REGULAR MEETING OF THIRD LAGUNA HILLS MUTUAL ARCHITECTURAL CONTROL AND STANDARDS COMMITTEE*

**Monday, November 13, 2023 – 1:30 p.m.
Laguna Woods Village Board Room/Virtual Meeting
24351 El Toro Road, Laguna Woods, California**

DATE: November 13, 2023
FOR: Architectural Control and Standards Committee
SUBJECT: Revision to Standard 18: Gutters and Downspouts

DATE: November 13, 2023
FOR: Architectural Control and Standards Committee
SUBJECT: Revision to Standard 11: Exclusive Use Common Area Floor Coverings

ATTACHMENT 3 – REDLINED REVISED STANDARD 18:
GUTTERS AND DOWNSPOUTS

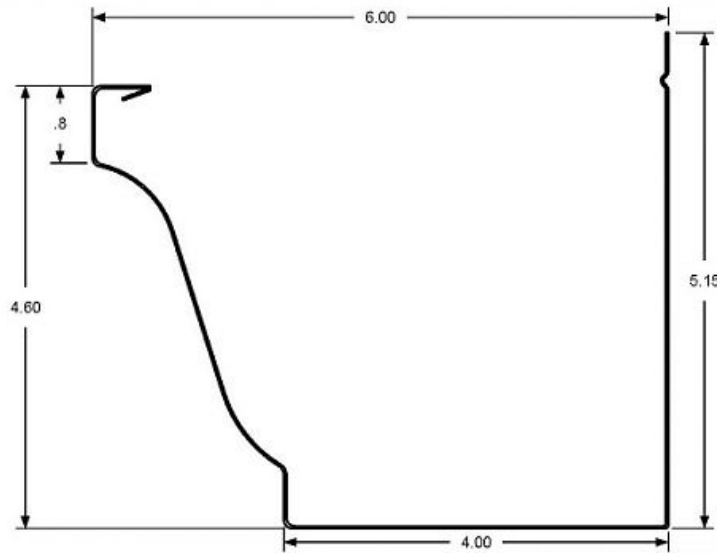
In order to improve the flow capacity of rain gutters and reduce maintenance, staff proposes to revise this standard to use K-style rain gutters (similar to the ones that VMS contractors use when installing or replacing rain gutters).

- 2.1** All gutters and downspouts shall have a slope of not less than 1/8-inch per foot along their entire length. Gutters and downspouts shall be installed so that water does not pool at any point. A splashblock will be required in areas where a downspout empties into an area in which erosion may result.
- 2.2** Downspouts shall be installed along every 25 feet to 30 feet of guttering. No downspout may be installed that will drain into an area that will effect surface drainage in an adverse way.
- 2.3** ApplicationsInstallations to roof systemss where hangers penetrate or may harm the roofing material in any way are prohibited.
- 2.4** All gutters are to be 6-inches wide as measured across the top. Gutters are to be made of aluminum with a minimum gauge of .027. Vinyl coated aluminum is permitted copper and steel gutters or downspouts are not permitted.

- 2.5 All downspouts to be seized at 4 inches by 6 inches to match color of existing guttering. and downspouts shall be seamless and the same style and color as the existing gutters on the building.
- 2.6 Termination of all downspouts must be at least 48-inches away from the face of building. A combination of downspout and splash blocks may be used to achieve minimum distance.
- 2.7 Downspouts that terminate directly into a drain inlet must provide a 1-inch air gap at point of transition.
- 2.42.8 In order to assist in substantially reducing a maintenance costs; prevent pest infestations and breeding sites; provide fire protection from flying embers and prevent obstructions – Gutter / Leaf Guards are required.
- 2.52.9 Gutters and downspouts will be of the same color to match the surface they are attached to.
